**PLANNED UNIT DEVELOPMENT
STAFF REPORT****Date: September 7, 2017**

<u>NAME</u>	Ken Knuckles (Development Management Group, LLC)
<u>LOCATION</u>	4803, 4805, 4807, 4811, 4819 & 4821 Moffett Road (Southwest corner of Moffett Road and Forest Hill Drive)
<u>CITY COUNCIL DISTRICT</u>	District 7
<u>PRESENT ZONING</u>	B-2, Neighborhood Business District
<u>AREA OF PROPERTY</u>	.38± Acre
<u>CONTEMPLATED USE</u>	Planned Unit Development Approval to allow shared access and parking between multiple building sites.
<u>TIME SCHEDULE FOR DEVELOPMENT</u>	Not Provided
<u>ENGINEERING COMMENTS</u>

SITE PLAN

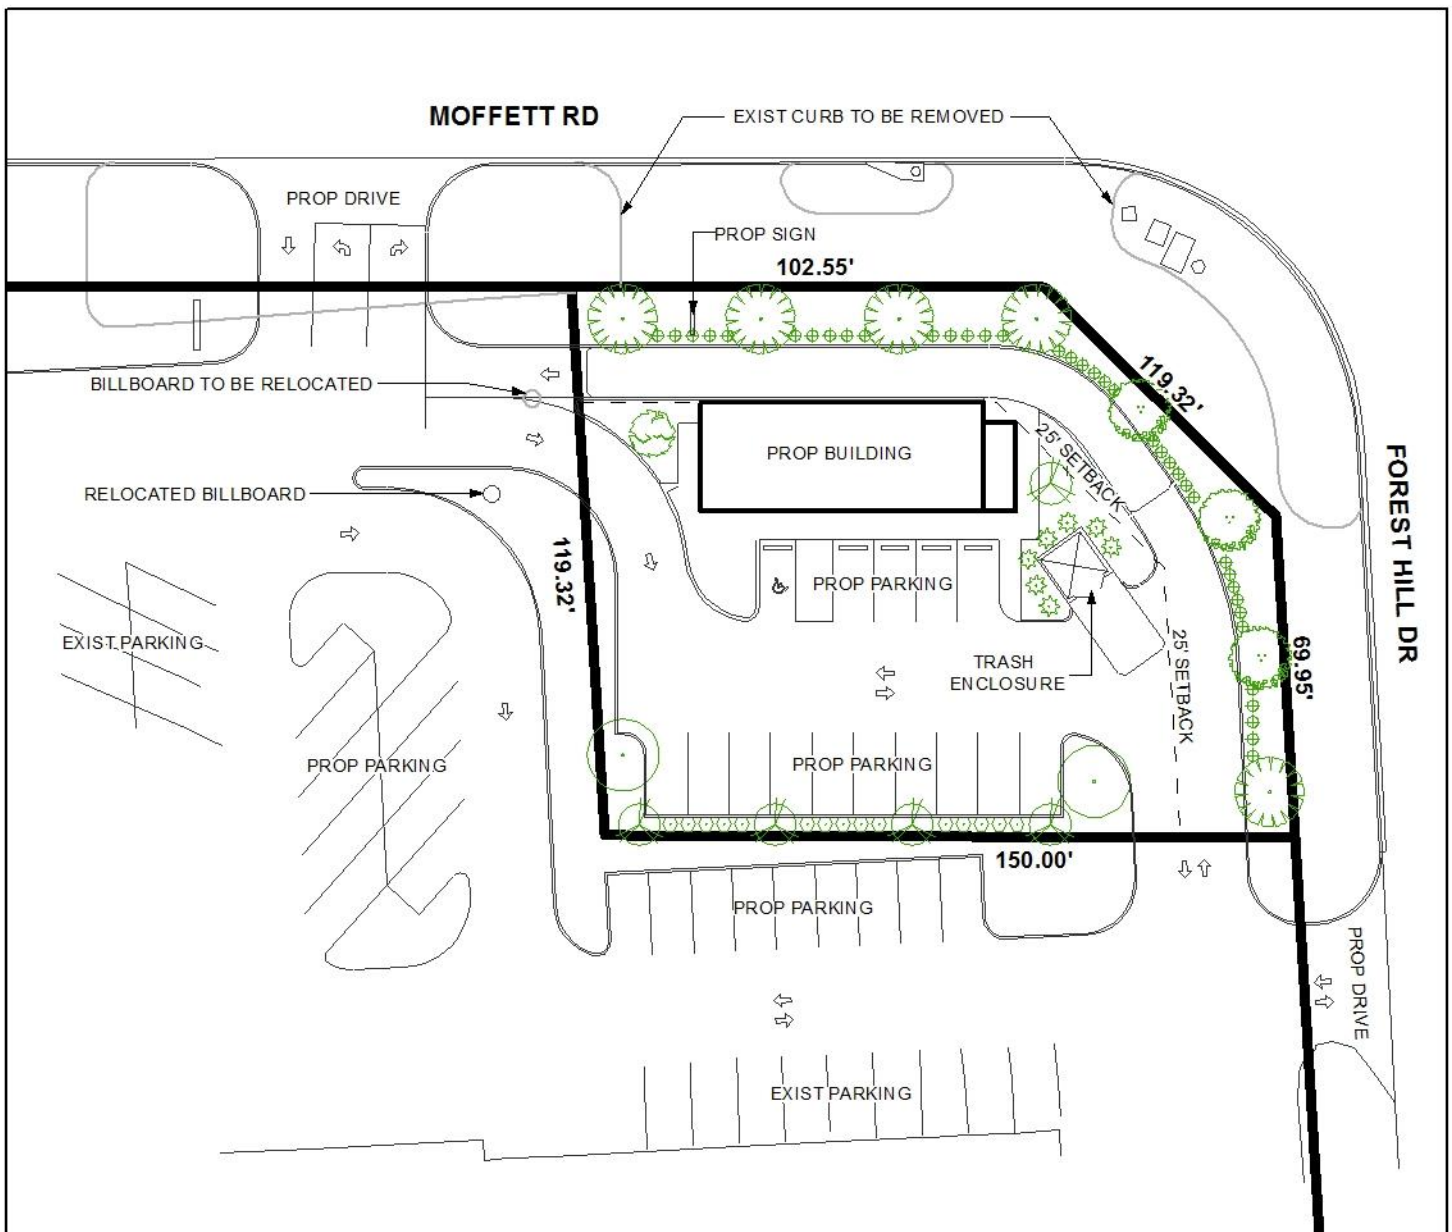
The portion of the overall site to be redeveloped is located at the southwest corner of Moffett Road and Forest Hill Drive. Moffett Road is a proposed Principal Arterial major street and requires a minimum right-of-way width of 100 feet. Moffett Road is also an ALDOT regulated facility. Forest Hill Drive is a proposed Major Collector street, and, as it lacks curb and gutter, should have a minimum right-of-way width of 60 feet. The site plan does not indicate the existing right-of-way width of either street.

In addition to meeting the required number of parking spaces for site compliance, Section 64-4.F.2. of the Zoning Ordinance states that drive-thru restaurants require a minimum of three (3) queuing spaces from the street right-of-way to the order station if both an order station and service window are provided in separate locations. Additionally, a minimum of three (3) queuing spaces between the order station and the service window is also required. A queuing space is defined as a minimum of nine (9) feet wide by twenty (20) feet long; therefore, a minimum distance of 60 feet is required from the street right-of-way to the service window, as well as between the order station and the service window. It appears that the proposed site may meet the required queuing spaces needed for the proposed development; however, the site plan does not indicate/label the location of the service window in order to make the appropriate determination.

It appears that most of the parking stall dimensions and the access aisle widths reflect compliance with Section 64-6.A.2. of the Zoning Ordinance; however, the handicap parking space depicts a width of eight (8) feet and should be revised to meet the minimum 9' wide by 18' long parking stall dimension required by the Zoning Ordinance.

The site plan is not shown in its entirety. As previously mentioned, it is unclear if the remaining development has adequate parking and aisle widths to accommodate the existing and proposed commercial business uses. The site plan should be revised to depict all parking spaces, aisles, and access and maneuvering areas. The Zoning Ordinance requires that a commercial business provide a minimum of one (1) parking space per 300 square feet of gross floor area. The applicant should provide a list of the use and square footage of each tenant space in the multi-tenant retail center to further ensure that the site provides a compliant number of parking spaces for customers.

The proposed restaurant development also requires that landscaping and tree planting requirements be met. The landscape/tree plan should be revised to provide the total site area in square feet. Additionally, the landscaping calculations should be revised to include the total number of perimeter overstory and understory trees, as well as the total number of understory parking trees required. This site requires (8) frontage trees, in addition to (1) understory parking

A dumpster, as indicated on the site plan, will be provided as the method of garbage collection for the new development; however, the site plan must be revised to indicate the height and enclosure material of the dumpster. The connection to sanitary sewer services was noted via a note on the site plan.

It appears that the proposed order station/menu board will be within the 25 foot setback. If the board will be more than 3 feet in height, a variance will be required.

Due to the corner redevelopment and extensive right-of-way work along Moffett Road, a sidewalk will be required along the Moffett Road frontage for the entire site, and along the Forest Hill Drive portion where the redevelopment will take place.

The proposed development appears to be in keeping with the character of the area and the Zoning Ordinance; however, the development should be shown in its entirety on the site plan since modifications will be made to the interior parking area shared between the business sites to ensure compliancy.

- 1) Submission of a two-lot subdivision application;
- 2) Revision of the site plan to depict the planned unit development in its entirety;
- 3) Revision of the site plan to show the location of the service window;

- 4) Revision of the handicap parking space to meet the minimum 9'x 18' parking stall dimension requirements;
- 5) Revision to indicate the minimum existing right-of-way width for both Moffett Road and Forest Hill Drive so that it can be determined if right-of-way dedication is required;

- 6) Indicate the height of the order board;
- 7) Depict provision of sidewalks as noted in the report;
- 8) Compliance with Engineering comments (ADD THE FOLLOWING NOTES TO THE PUD SITE PLAN: 1. Any work performed in the existing ROW (right-of-way) such as driveways, sidewalks, utility connections, grading, drainage, irrigation, or landscaping will require a ROW permit from the City of Mobile Engineering Department (208-6070) and/or ALDOT and must comply with the City of Mobile Right-of-Way Construction and Administration Ordinance (Mobile City Code, Chapter 57, Article VIII). 2. A Land Disturbance Permit application shall be submitted for any proposed land disturbing activity with the property. A complete set of construction plans including, but not limited to, drainage, utilities, grading, storm
